To: T10 Technical Committee
From: Rob Elliott, HP (elliott@hp.com)
Date: 28 March 2008
Subject: 08-183r0 SAS-2 Add device slot numbering fields to DISCOVER

This proposal is a SAS-2 letter ballot comment.

Figure 1 — Device slot number examples

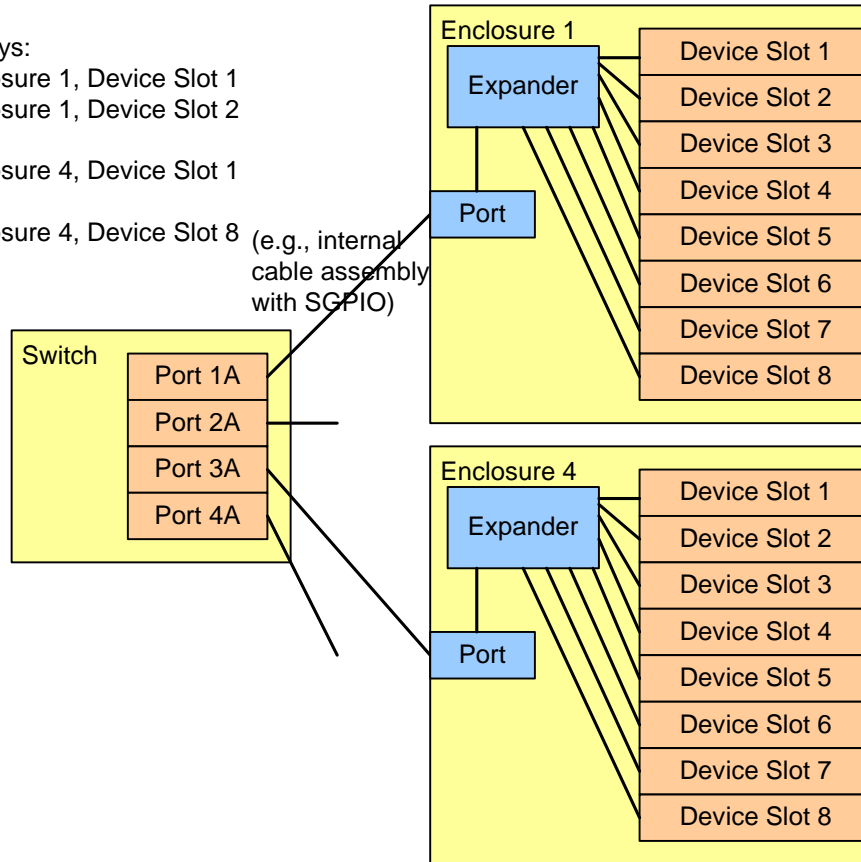
Instead, a few more SES fields can be included into the DISCOVER response:

- a) Device Slot Number - a number used to identify the bay (i.e., device slot) within the enclosure. Binary number 1-254 (255 means no bay).
- b) Enclosure Number - a number used to identify the enclosure within a set of enclosures (e.g., the depth in a daisy-chain). Binary number 1-254 (255 means no number).
- c) Path To Enclosure - a 2-byte ASCII string used to identify the path to the enclosure (e.g., a switch port number). Two ASCII spaces mean no path identifier.

Different systems will use different terminology for the levels; the key request is that 3 levels be possible.

Sample displays:

Port 1A, Enclosure 1, Device Slot 1

Port 1A, Enclosure 1, Device Slot 2

Port 3A, Enclosure 4, Device Slot 1

Port 3A, Enclosure 4, Device Slot 8 (e.g., internal cable assembly with SGPIO)
